IEEE 802.3da SPMD: MPoE: **Multiple MPIs per DTE**

Peter Jones, Cisco Systems
May 2025

802.3da D2.2 defines LLDP TLVs for a single MPI per DTE. This document proposes changes to the current clause 30 and clause 79 draft text to support this/

Figure 189-1a - Example MPI to DTE associations

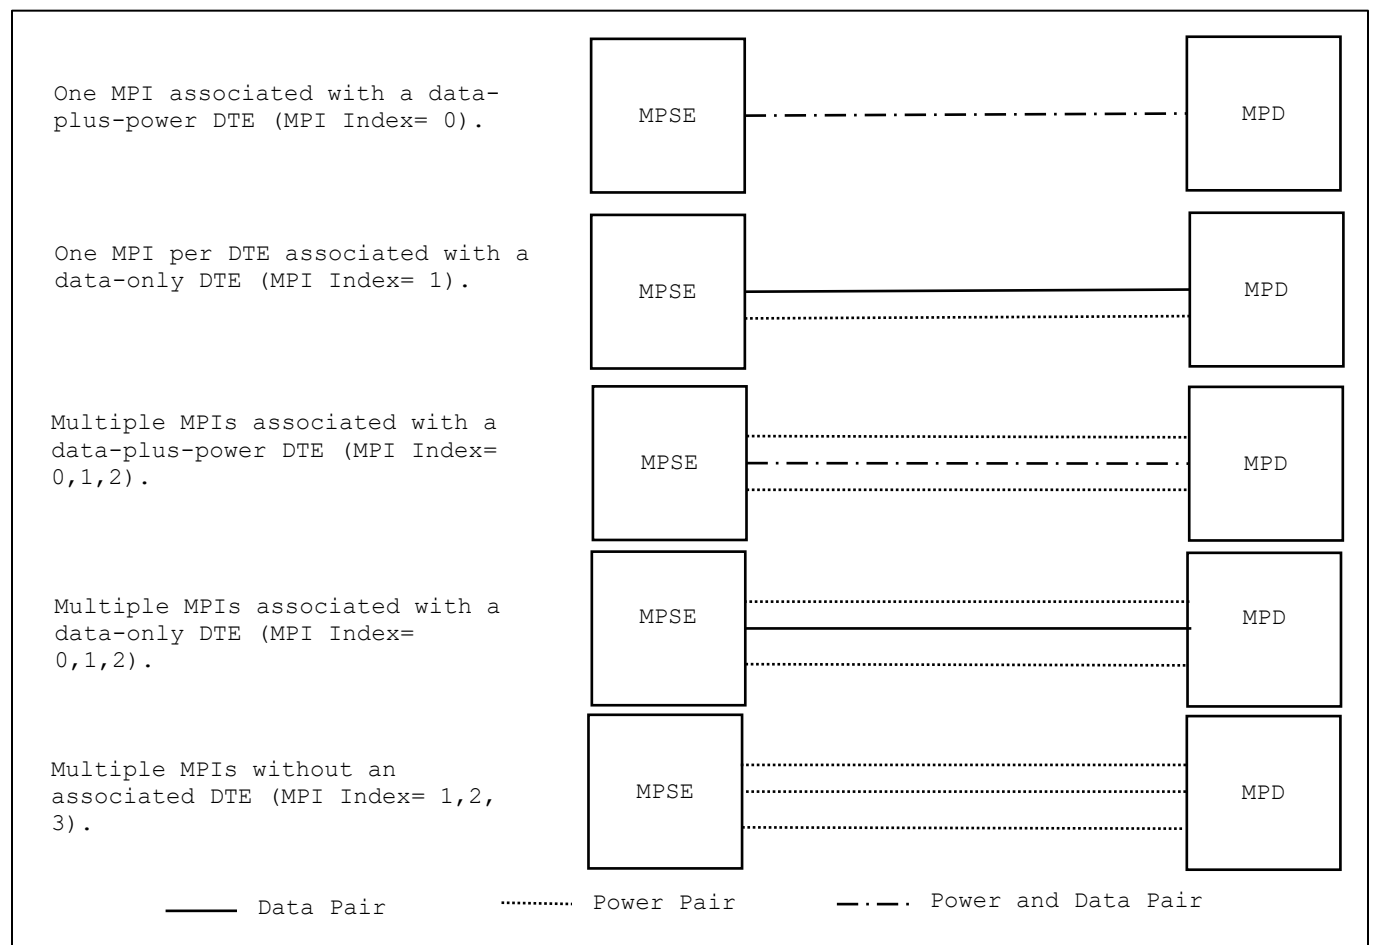
Add the following text after Figure 189–1 in 188.1.2

Figure 189-1a below illustrates (showing only two nodes for simplicity of drawing) some of the different types of MPI and DTE associations supported by MPoE.

189.1.2a.1 MPIs associated with a DTE

A DTE may be associated with 0, 1 or more than one MPIs. A DTE with 0 associated MPIs is a data only link. A DTE often has an MPI sharing the same power/data pair.
